**RE: Value Planning Study Final Report – Comox Valley Water Treatment Project**

# Value Propositions Implementation Response

# Value Planning Study

Alternative No.: IR-61

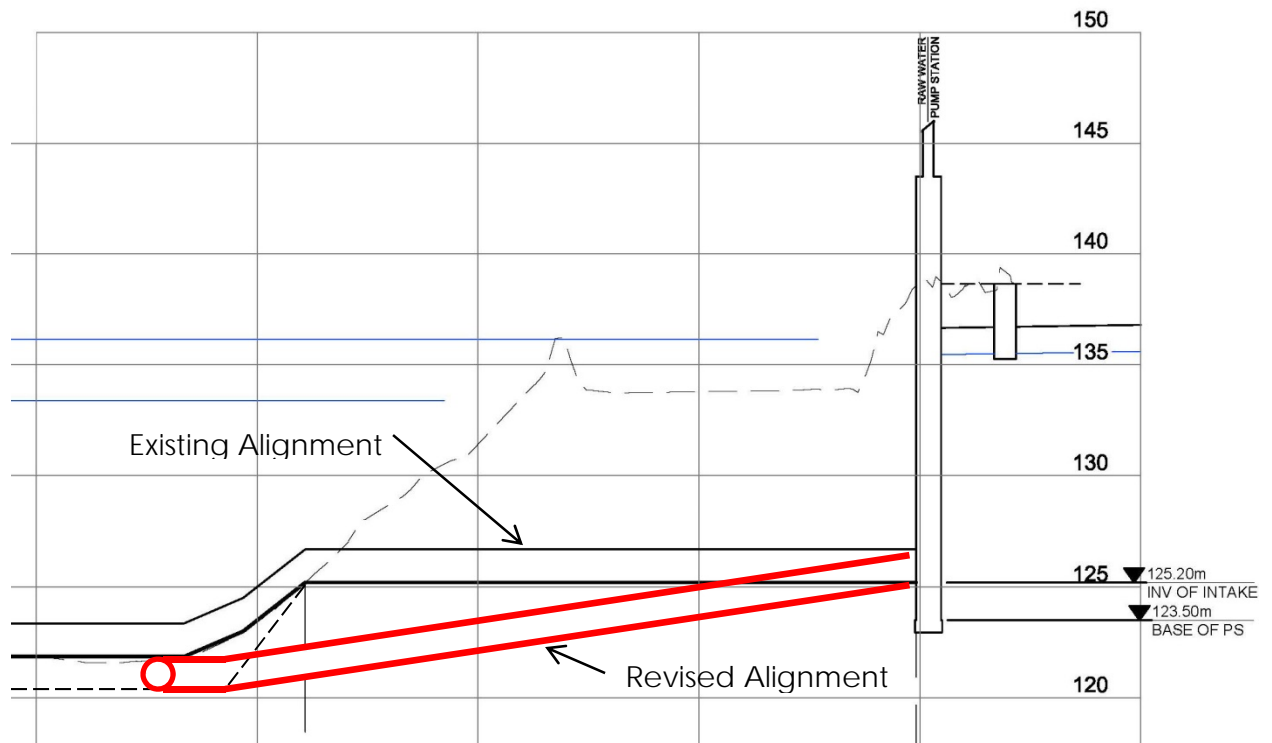
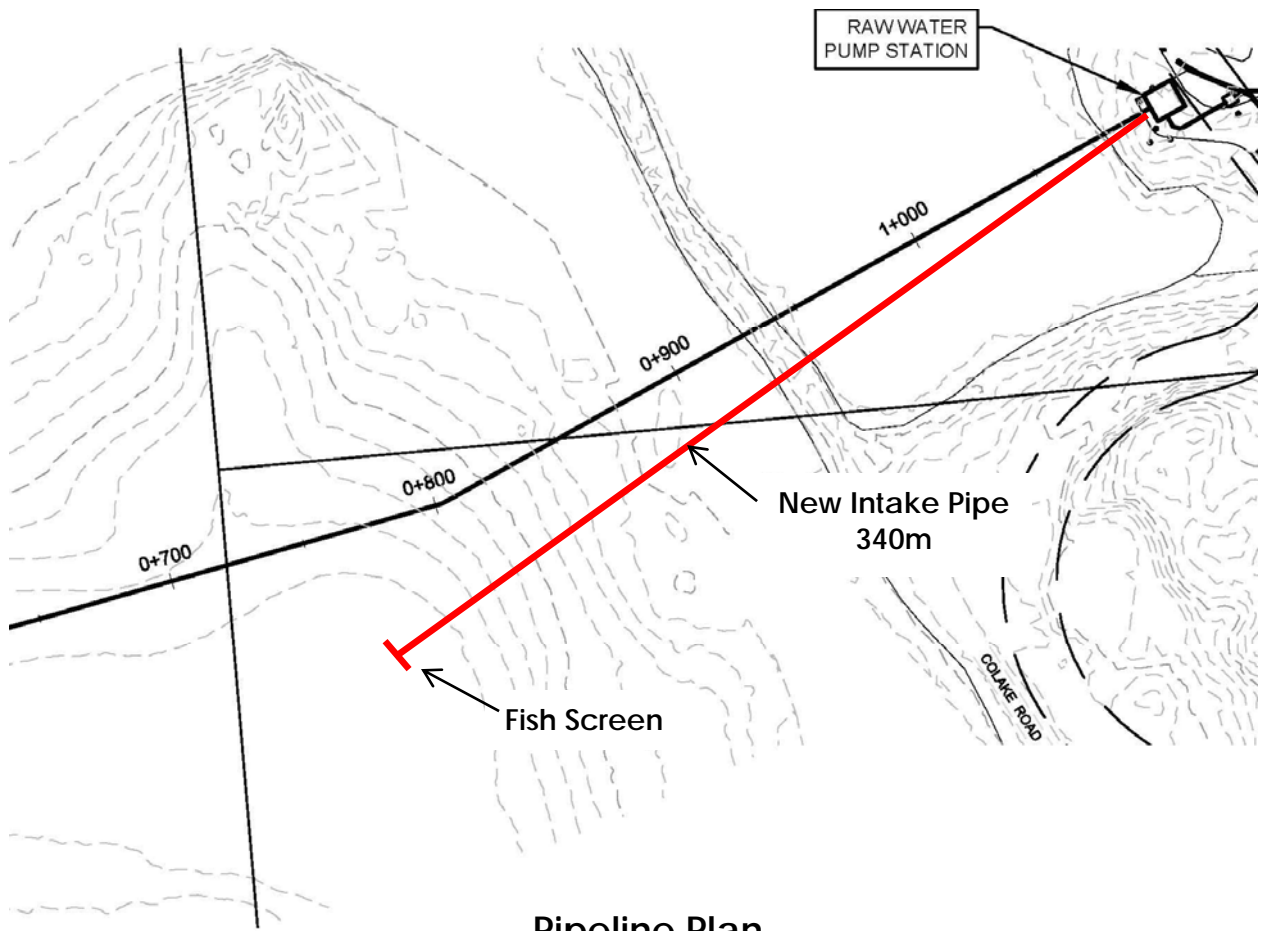
The VP Team is therefore proposing installation of the intake on a shelf in the lake at EL120. This will shorten the intake pipeline by approximately 835 meters and raise the intake elevation by 15 meters. This would place the top of the fish screen at about EL124, providing more than adequate navigational clearance even if the lake level is at the dam sill level. This change will reduce first cost and provide both construction and operation and maintenance benefits, as follows:

- Reducing the length will:
  - materially reduce construction time
  - reduce sediment generation during construction, reducing potential raw water turbidity impacts during construction
  - reduce construction impacts on lake biota
  - reduce construction impacts to the fish and game property
  - slightly reduce the suction head loss
- Locating the intake at the shallower depth will afford the following benefits:
  - The water will likely be warmer, affording improved flocculation for direct filtration and measurably reduced head requirements for membrane treatment
  - The shallower fish screen installation will simplify installation, improve diver efficiency, and simplify maintenance
  - The membrane system can be designed for a higher flex at the warmer temperature

Another change in the design is the decreased depth of the water in-take from EL105 to EL120 and the relocation of the RWPS adjacent to the spit. (IR-10,14,61). This reduces the length of the in-lake pipeline from 1100 m to approximately 160 m and decreases construction complexity. An investigation into the turbidity change of the lake with respect water depth found little change in the turbidity levels and the water quality can be maintained at this shallower depth.

Alternative No.: SC-01

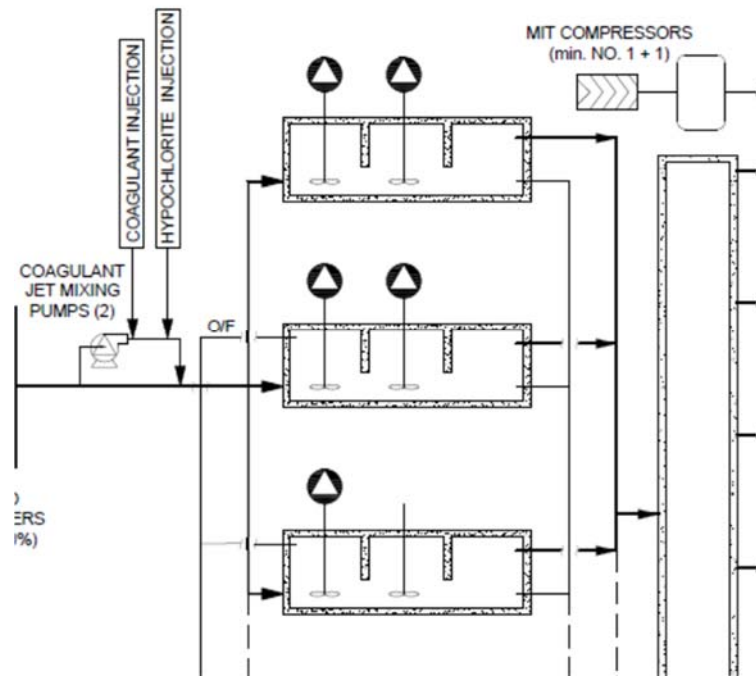
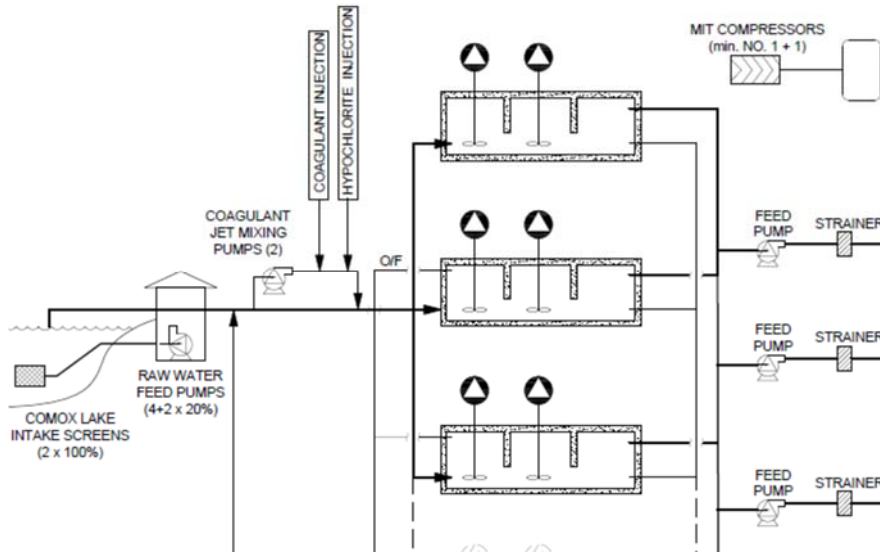
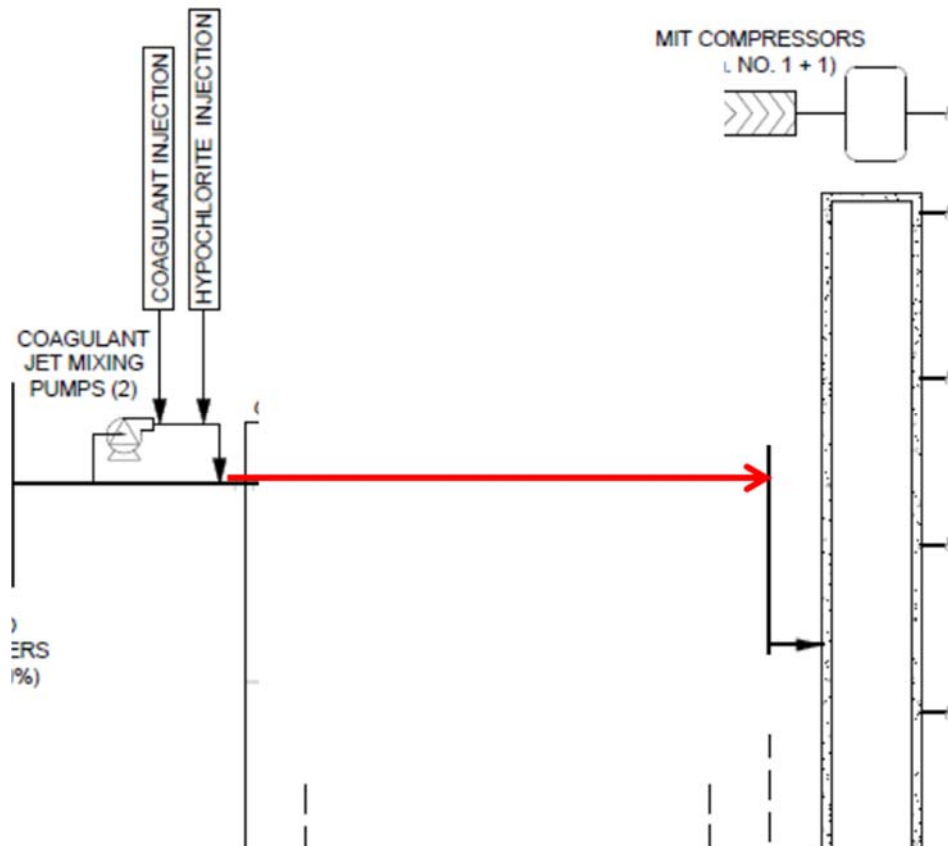
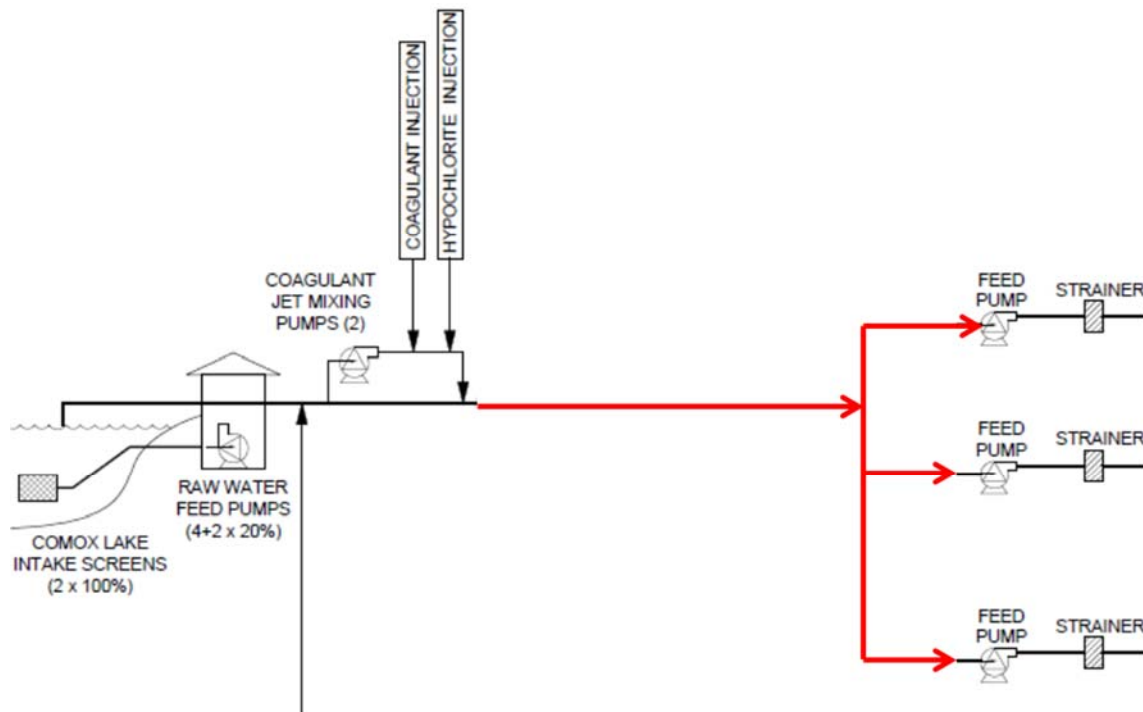
It would be prudent to install a direct inline coagulant injection point into the supply line to provide an opportunity to add coagulant at some point in the future.

Note to designer, the use of sodium hypochlorite as a feed to submerged membrane systems raises concern regarding corrosion of conduits and other metal structures and requires special consideration if carried through as a project requirement. PVC or PVC coated conduit will be required, and fiberglass structures are preferred over galvanized.

Alternative No.: SC-02

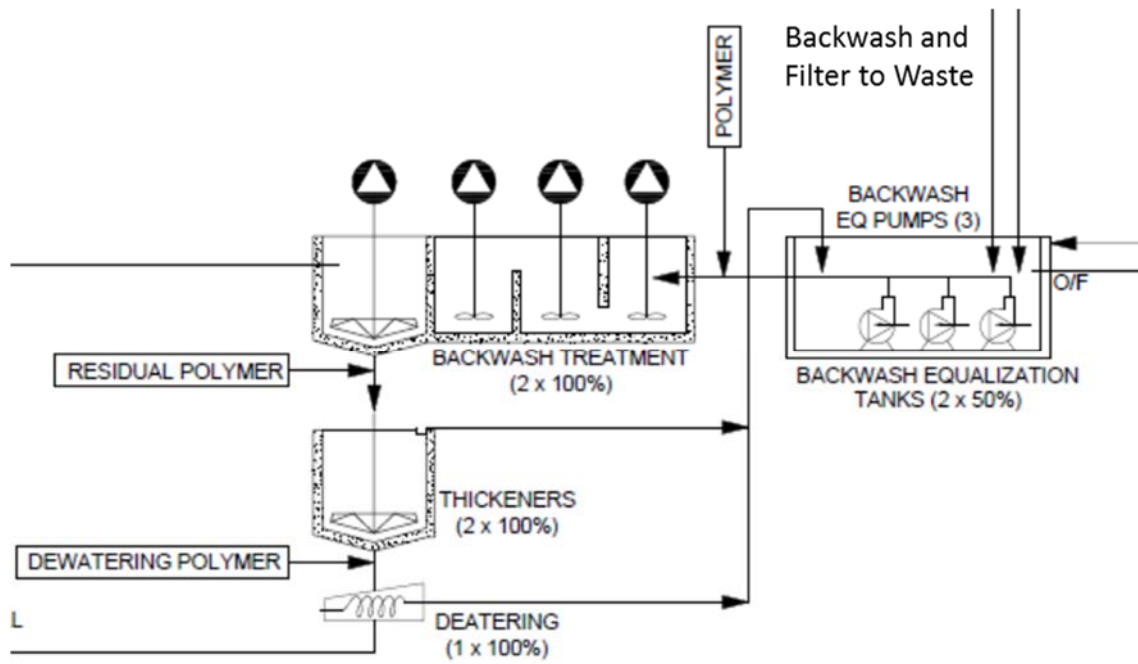
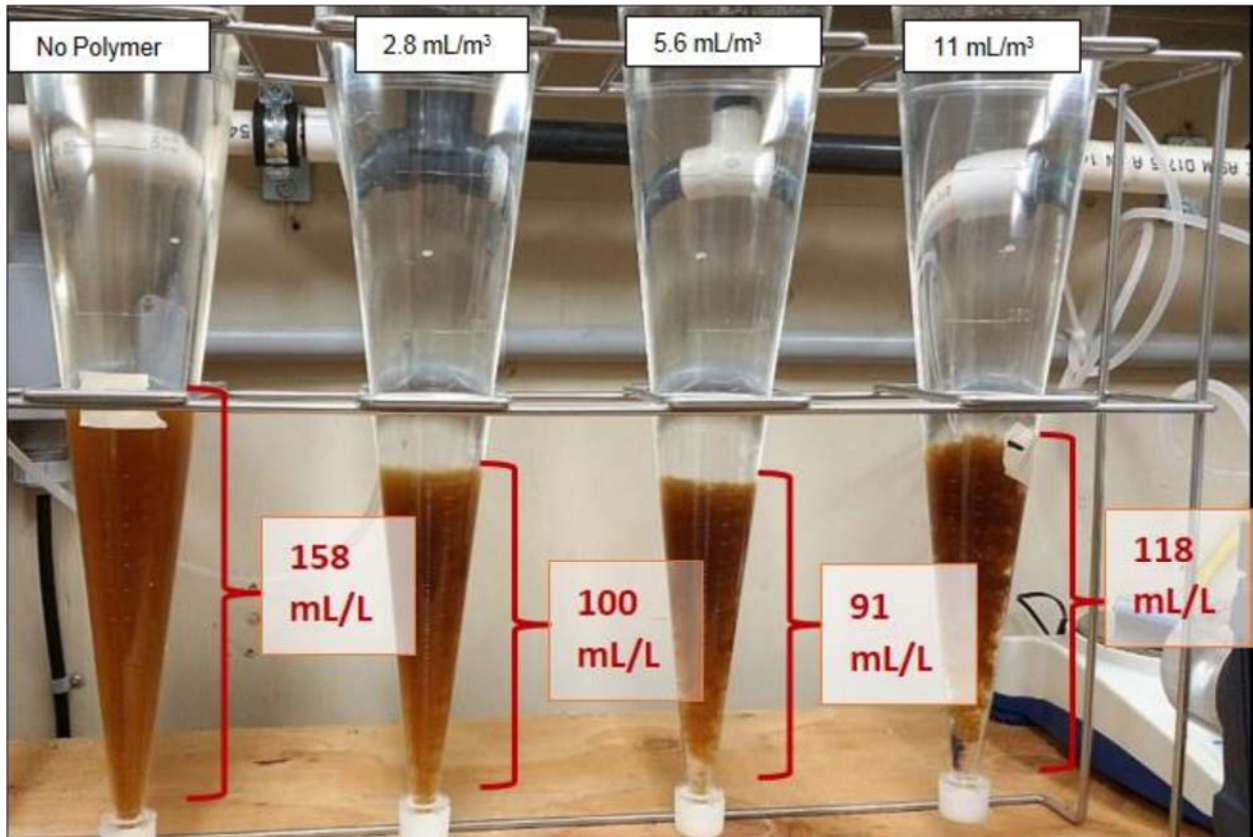
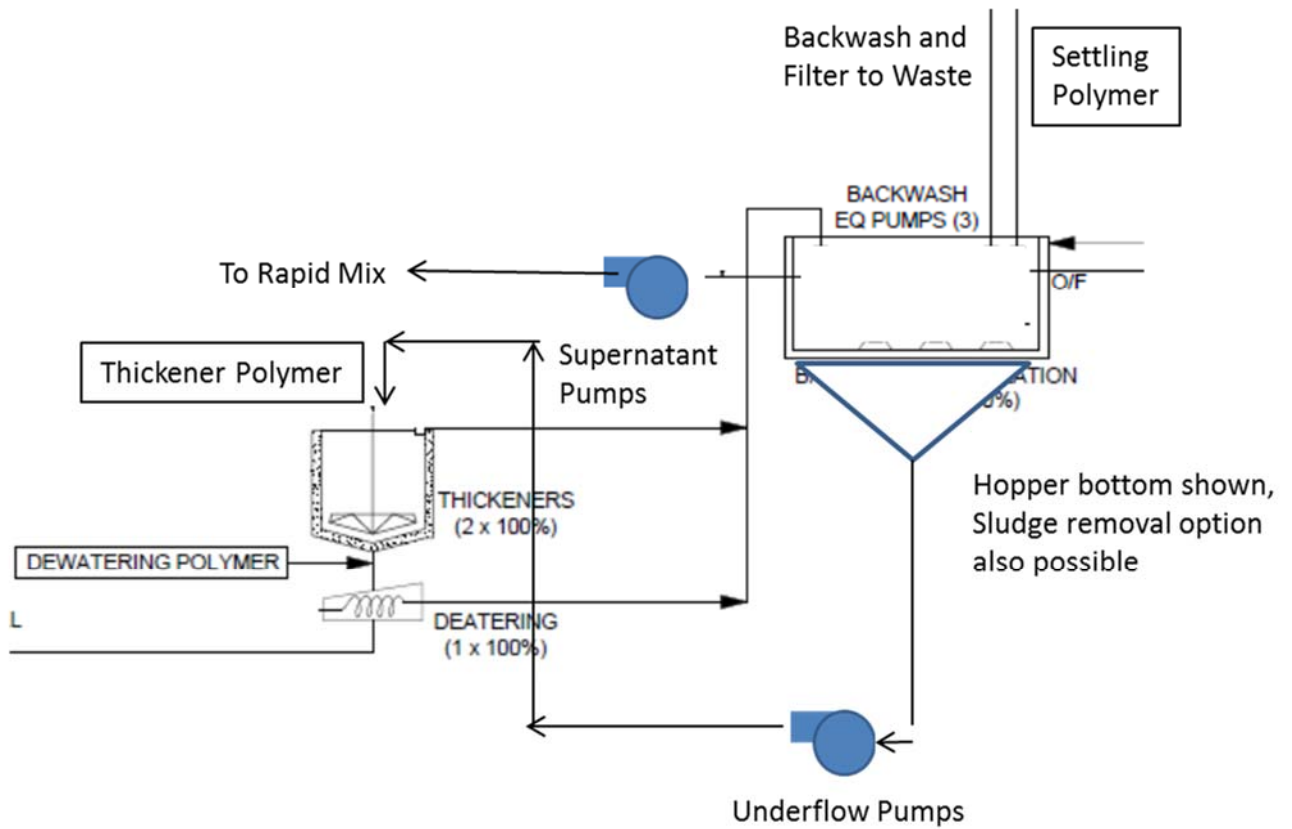
The proposed alternative would operate in fill, settle and drain mode. In the fill mode, backwash water would enter the basin, during the settling mode, the solids are allowed to separate. In the drain mode, the clarified water is returned to the rapid mix basin. Typically, the return rate from the backwash basin is no more than 10 percent of the feed rate to the filters in accordance with the filter backwash rule (USEPA) standard.

The more optimal configuration is a 3 x 50 percent configuration. The system is currently designed to accept 11.4 backwashes in total. With a total number of 8 filters, a backwash will occur every 32 hours based on the pilot study, thus the average backwash period is every 4 hours.

The backwash settles nicely without the use of polymer, although polymer could be added to the backwash water. A simpler approach is to use the backwash basins to settle the backwash water, then decant the supernatant, to the head of the plant and the solids to disposal.

Alternative No.: SC-13

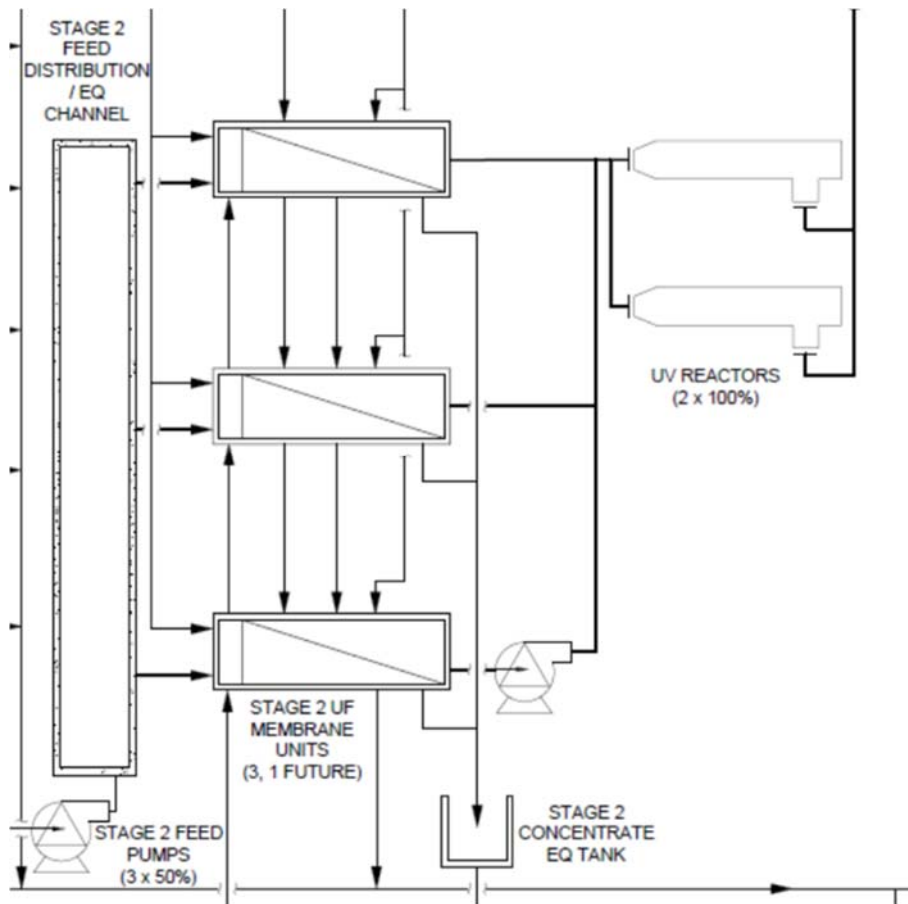
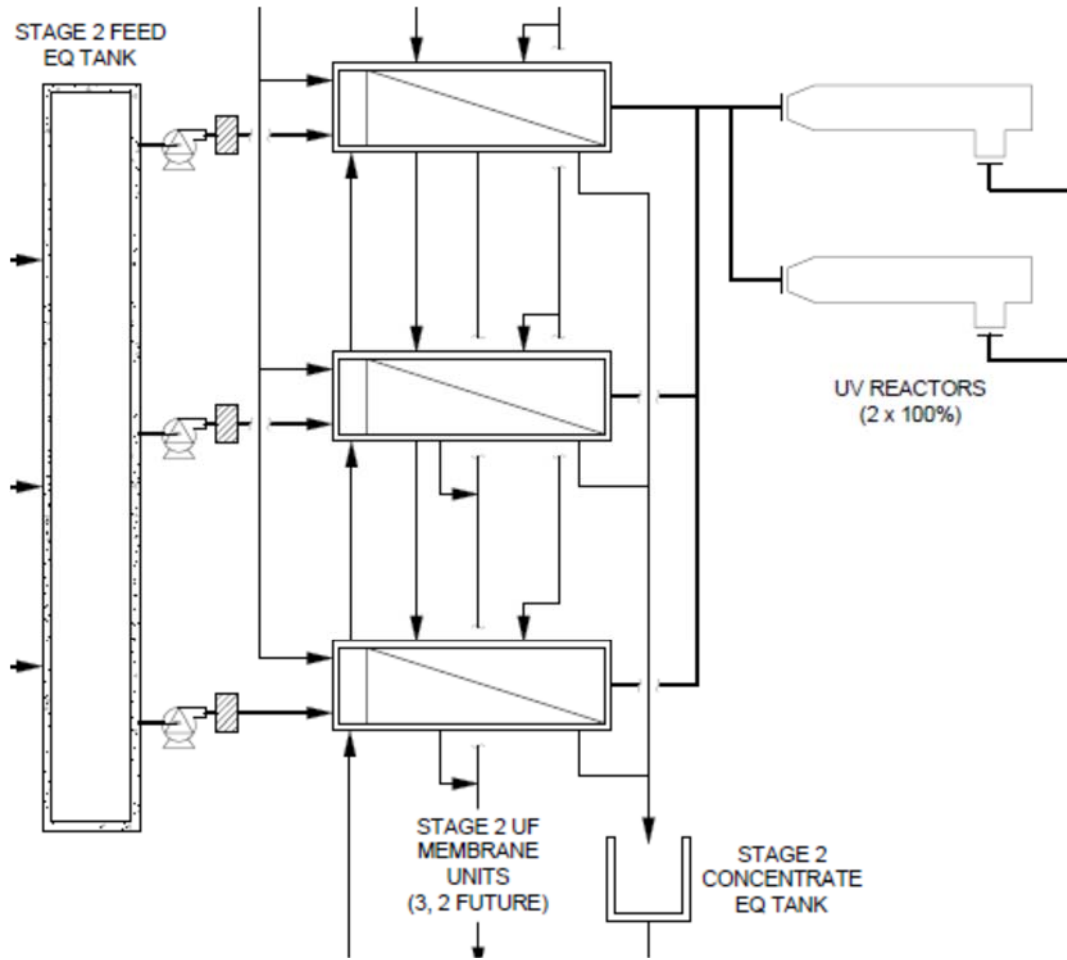
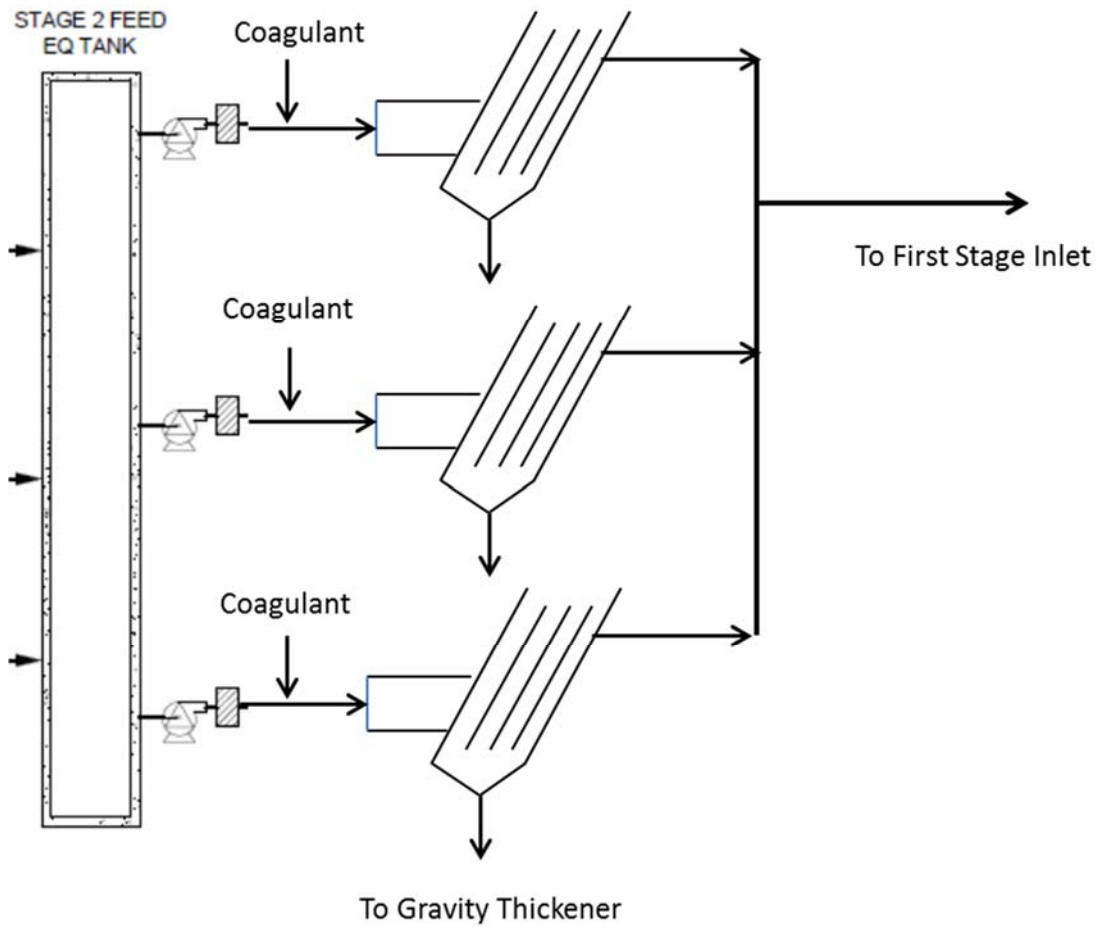
Instead of a two-stage system, a conventional plate settler or similar coagulation-based system is often a far more reliable and robust system. This type of system eliminates the challenges associated with the operation of a two-stage membrane system.

This option will also eliminate the need for second stage UV disinfection.
